County of Santa Cruz

Exhibit 2
A-3-SCO-09-001, -002, -003
Page 1 of 12

Pacific Crest Engineering, 2009, "Response to California Coastal Commission comments, Trousdale residence, A.P.N. 043-161-57, 660 Bayview Drive, Rio del Mar, Santa Cruz County, California", 18 p. Geotechnical Report dated 26 February 2009 and signed by E.M. Mitchell (GE 2718).

Pacific Crest Engineering, 2009, "Response to California Coastal Commission comments, Lands of Frank, Bayview Drive, A.P.N. 043-161-51, -40, -39, Rio del Mar, Santa Cruz County, California", 27 p. Geotechnical Report dated 26 February 2009 and signed by E.M. Mitchell (GE 2718).

Recent bluff failure on APN 043-161-51; photos taken 4 Mar 2009

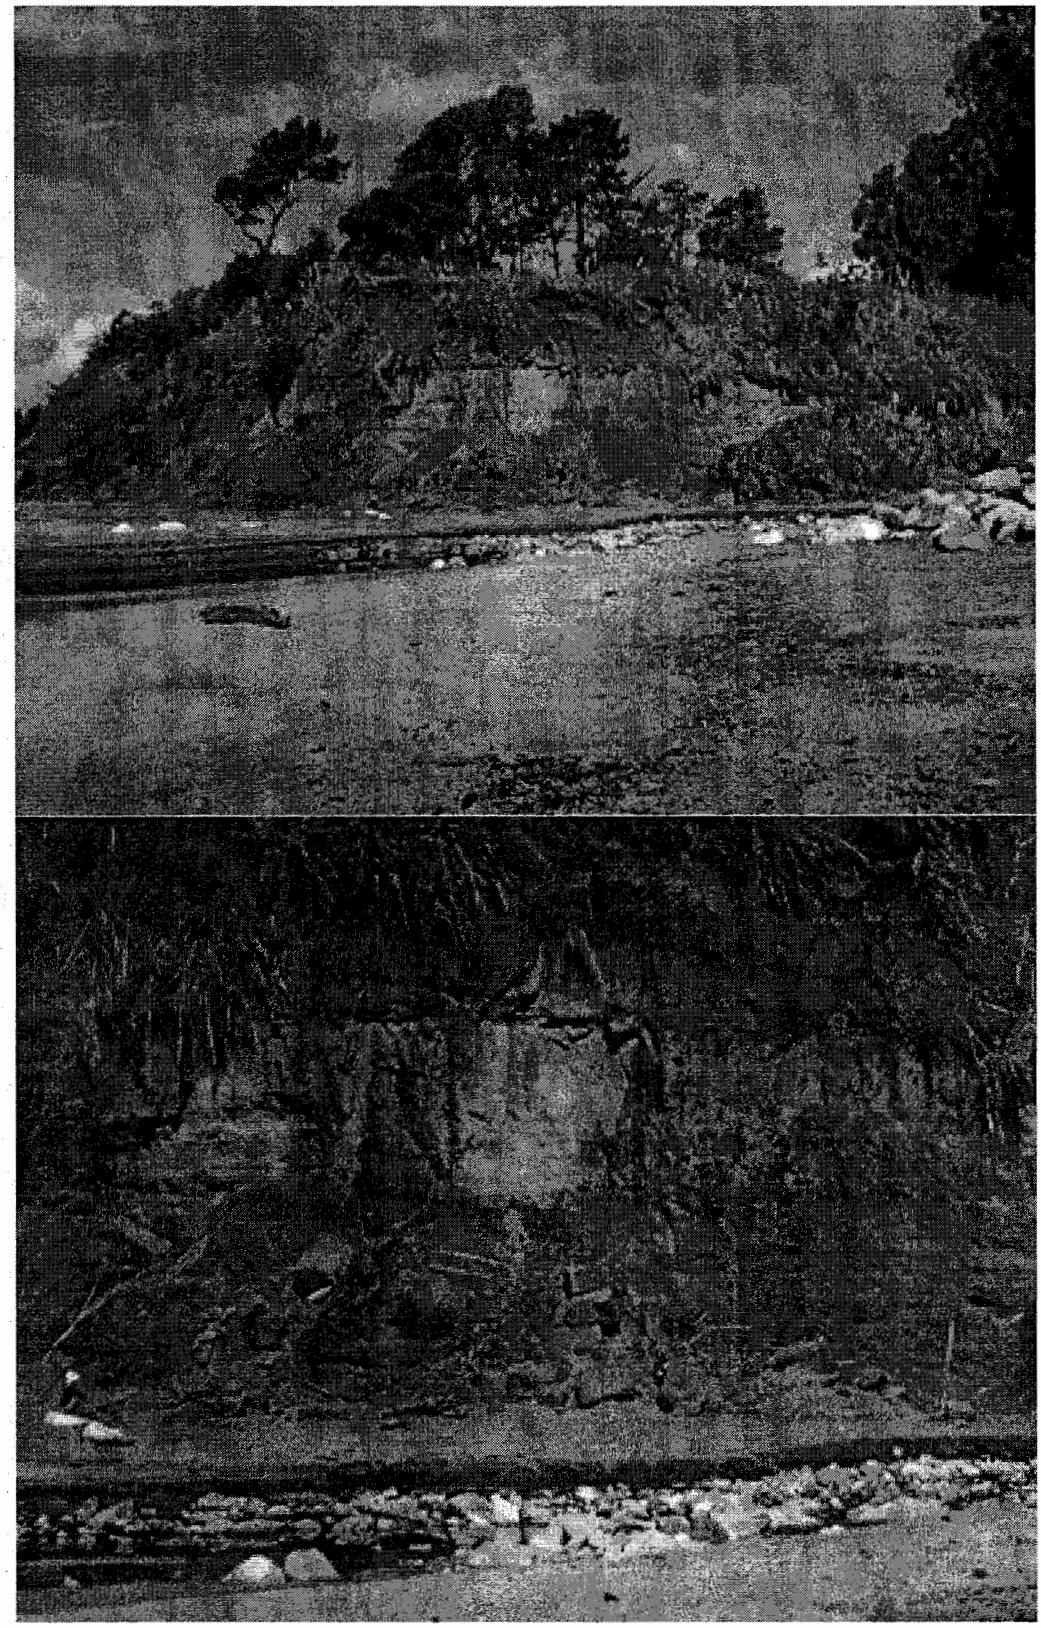
As is apparent from their titles, these reports were written in response to questions that I raised in an earlier review of geotechnical reports related to the proposed development of these parcels. Specifically, a request was made to evaluate future coastal erosion and bluff retreat to be expected on these parcels over the 100-year design life of the proposed development taking into account anticipated acceleration of the current rate of sea level rise. Further, I requested refined quantitative slope stability analyses that would supplement earlier analyses which I felt were too restrictive of potential failure mechanisms.

Figure 1. Abandonment of the Erosional Sea Cliff

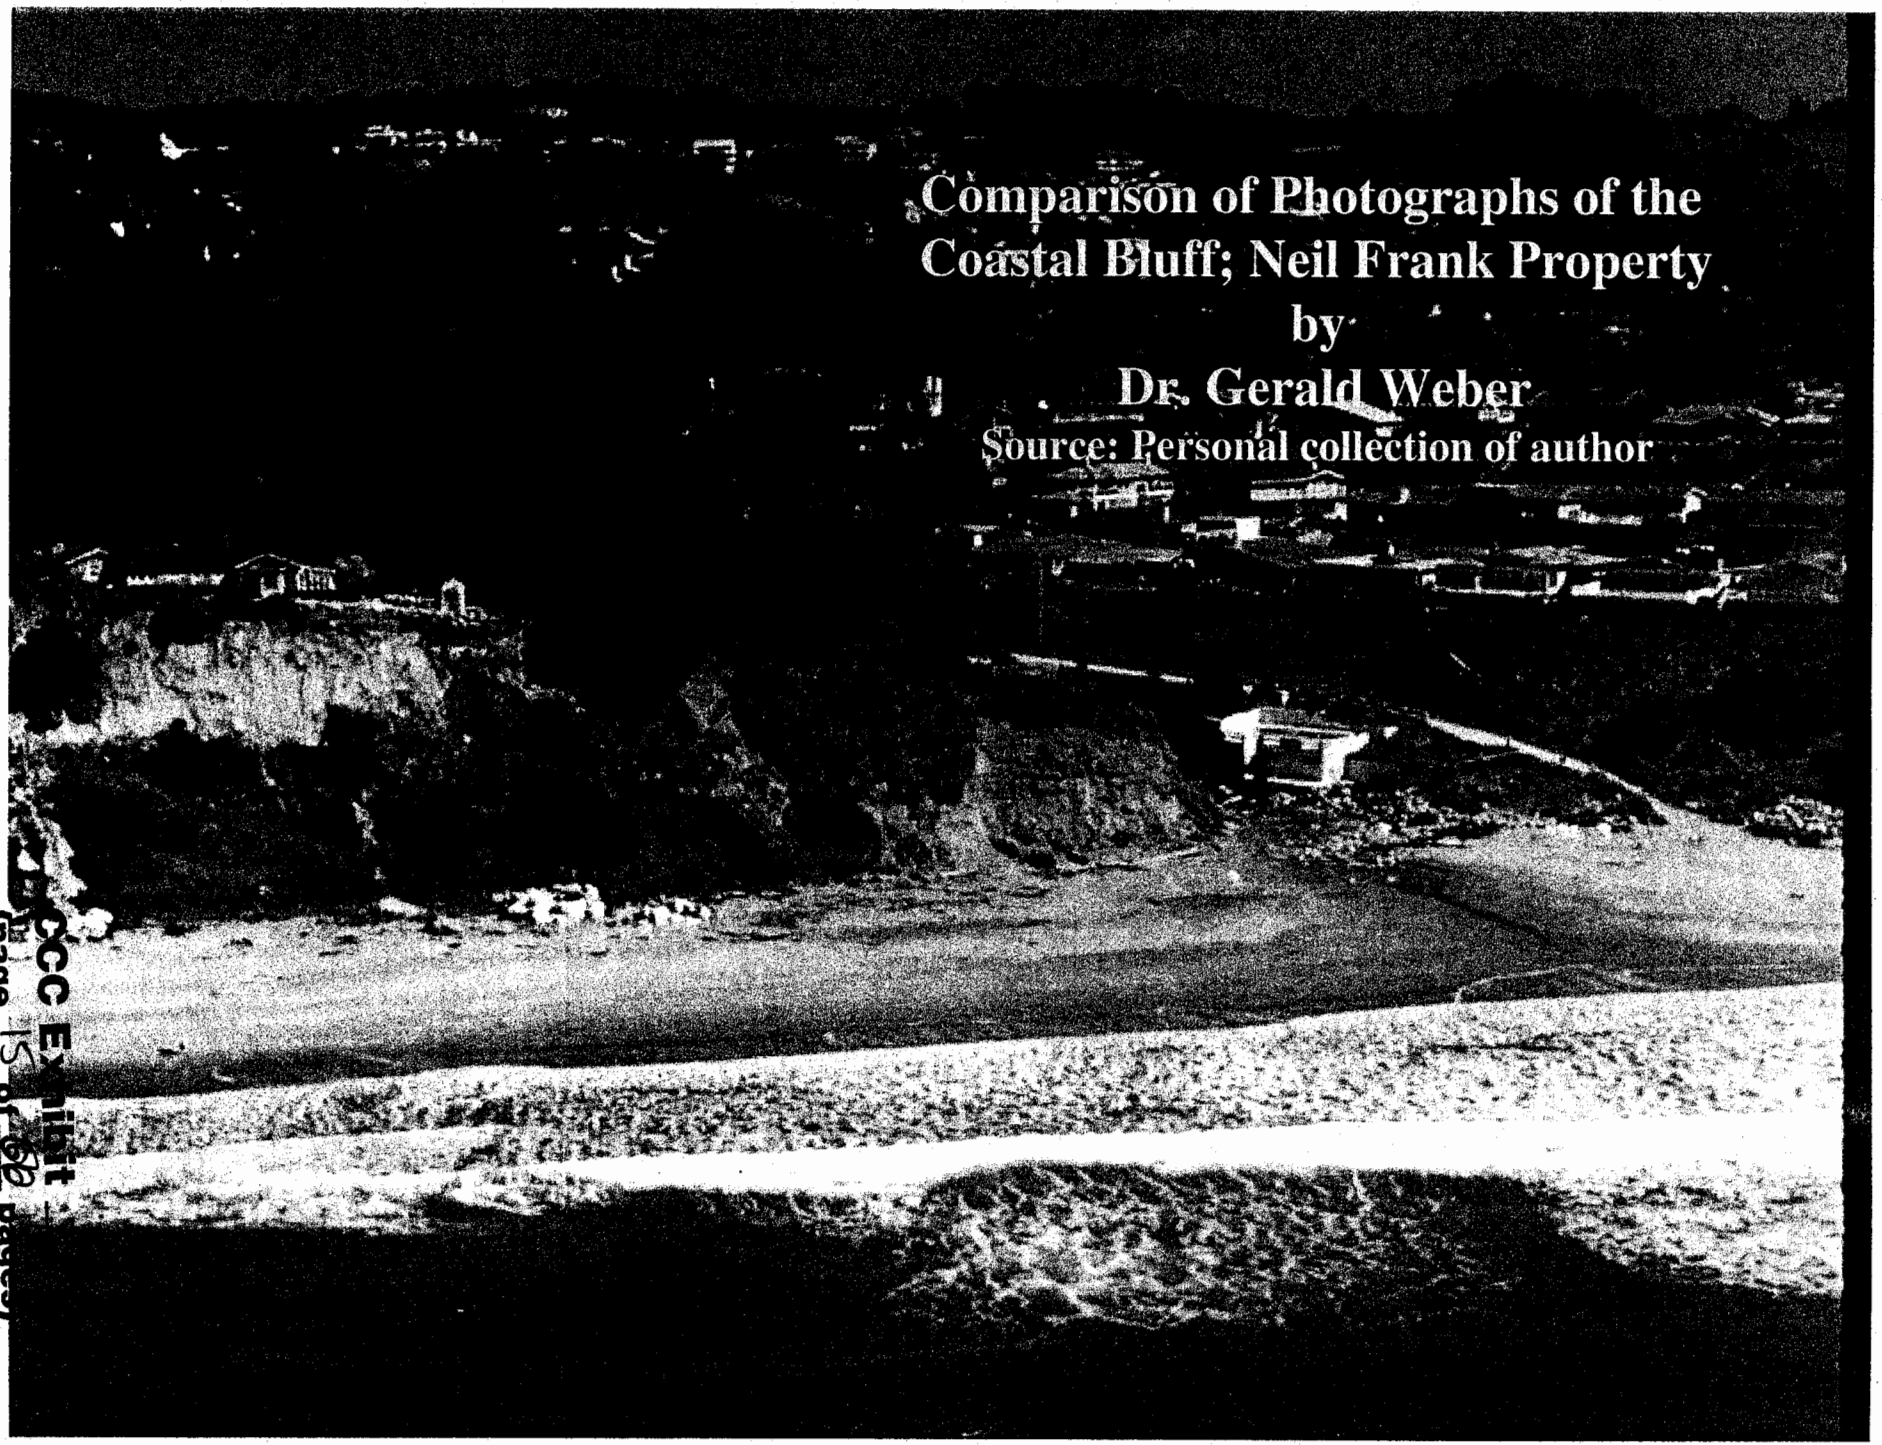
To avoid confusing the reader it is important to clearly define the terms that I will use in this discussion. Please refer to Figure 1.

Figure 11. Wave erosion at subject properties – January 23, 1983. The only time the beach has been stripped in the past 39 years. Evidence that the base of the erosional sea cliff is above the level of wave attack.

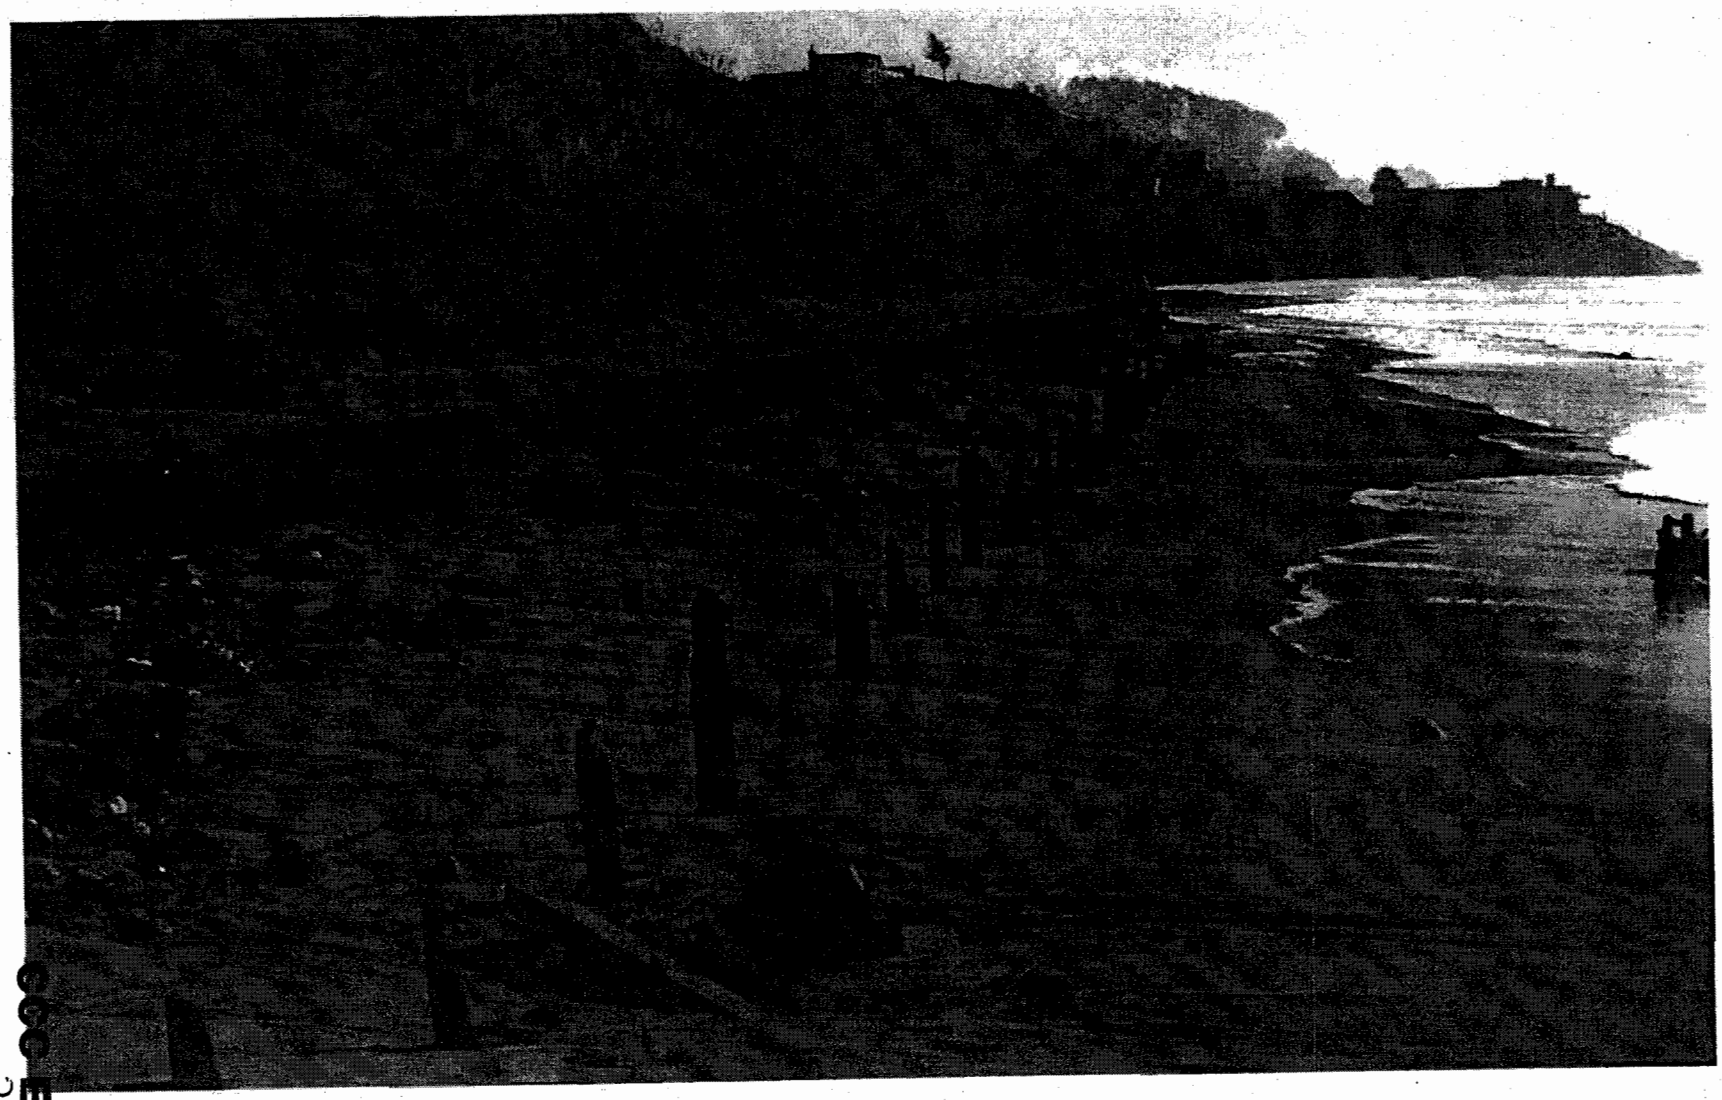
Figure 10 presents two photos of the extent of the erosion immediately south of Via Gaviota. Note that the waves have only eroded into the toe of the colluvial wedge, and have not eroded the base of the abandoned sea cliff. Figure 11 is taken north of Via Gaviota showing the beach in front of the subject property. The colluvial wedge is barely eroded. This is the thinnest beach that I have personally observed in this area over the past 39 years. Figure 12 shows the beach fronting the subject property in November 2000.

The same storms severely damaged homes along Via Gaviota and at Pajaro Dunes (Figure13) and elsewhere along the northern Monterey Bay shoreline. The homes at Pajaro Dunes which are built at the upwind edge of an active dune field on the active beach were severely damaged. Yet a short distance north at Sunset Beach (Figure 13) the waves created only a small scarp in the colluvial wedge at the base of the sea cliff. At Hidden Beach which fronts the subject property, the same storms stripped sand off of the beach exposing the risers for the sewer line, but only slightly eroded into the toe of the colluvial wedge at the base of the cliff (Figure 11).
